ADDENDUM 01

Project: Historic Humber House Repairs
SCO #: 23-26910-01A

LYSAGHT & ASSOCIATES, P.A. – STRUCTURAL OBSERVATION REPORT

Date: April 22, 2024
Recipient: Yujie Cui
Email: yujie@clearscapes.com
Subject: Structural Field Report
Project: Robert Lee Humber House Structural Observation
Site: 117 W 5th St, Greenville, NC 27858
Project #: 14520 (L&A)
Visit Date: April 10, 2024

PARTIAL 1ST FLOOR FRAMING SCHEMATIC

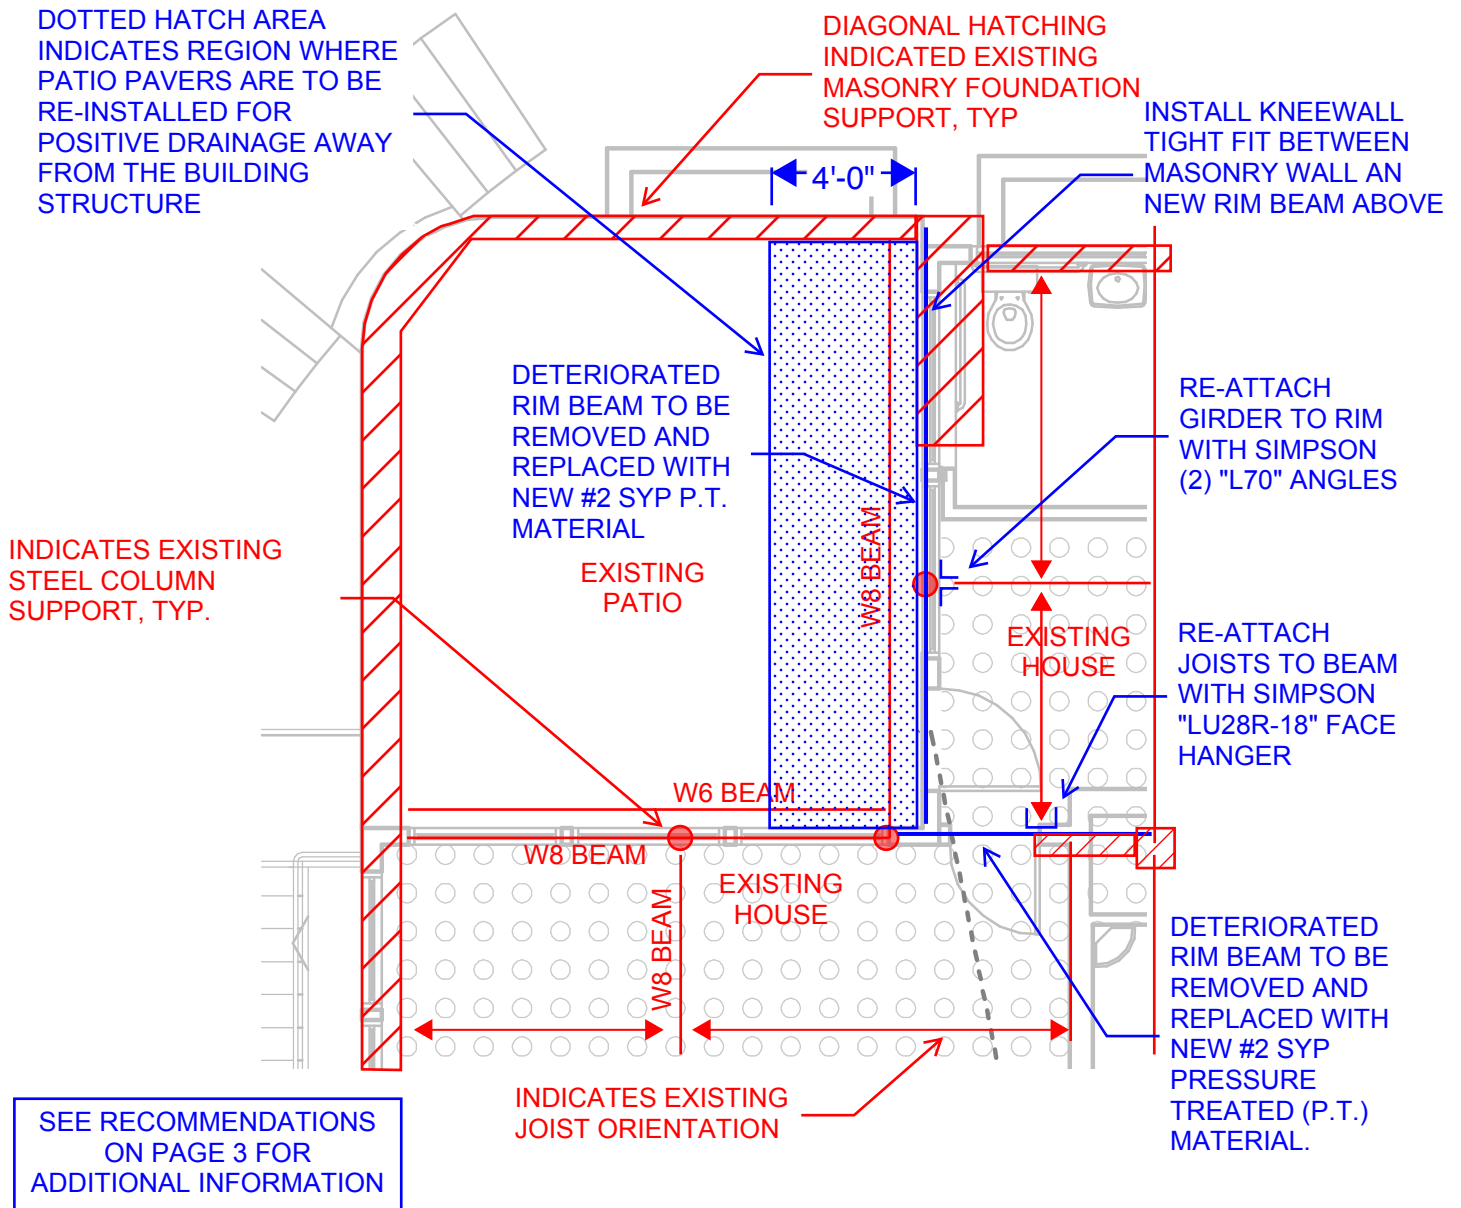
- i. In addition, the beam located at the front of the rim band was noted to be deteriorated beyond salvageable limits (*see picture 7 for example*) (*see schematic on page 3 for additional information*).

- 2) The existing left-to-right single ply beam/rim that supports the front-to-back deteriorated rim noted above shall be removed and replaced with a (2)2x10 beam, ripped down to a depth of approximately 8", such that the beam is flush with the underside of sheathing and with the top of end bearing supports (*see schematic on page 3 for additional information*).

- 1) The deteriorated rim band shall be removed and replaced with new (2)2x10 rim band, ripped down to a depth of approximately 8", such that the top of beam is flush with bottom of floor sheathing and bottom of beam is flush with the cap plate of the existing steel column.

- a. The new rim band shall have full bearing at the back foundation wall, and shall be attached to beam at front with Simpson face hanger.
 - i. Attach steel column cap plate to new rim beam with (2) ¼" x 4½" Simpson SDS screws. Drill 5/16" diameter holes in existing steel cap plate for attachment.

- a. Joists shall be attached to new beam with Simpson "LU28R-18" face hangers.
- 3) We recommend that the 4' wide section at the right side of the back patio be sloped 1/8" per foot minimum, and that the 1' section directly adjacent to the structure at the right side of the patio shall be sloped away from the structure 3/16" (minimum) over one foot.

*Picture 4 – Example of area of reported water
intrusion*

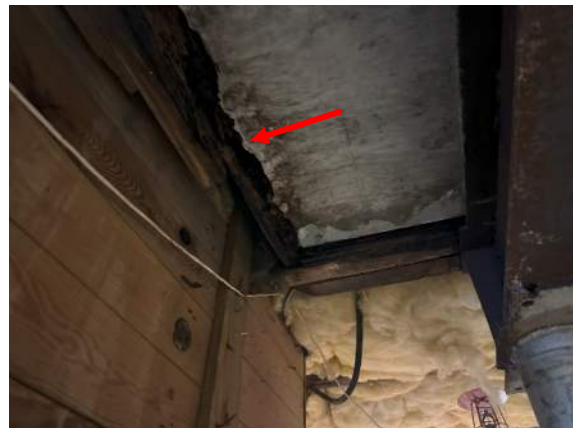
- 1) While on site, it was reported that a water-intrusion issue has been present in the basement beneath the transition from the right side of the elevated exterior patio slab and the exterior wall of the building (*see pictures 2-3 for examples*).
 - a. Further investigation beneath the patio slab revealed that the single 1 $\frac{3}{4}$ " x 7 $\frac{3}{4}$ " partially sistered rim band, beneath the left wall of the back-most portion of the building was deteriorated beyond salvageable limits (*see pictures 4-6 for examples*).
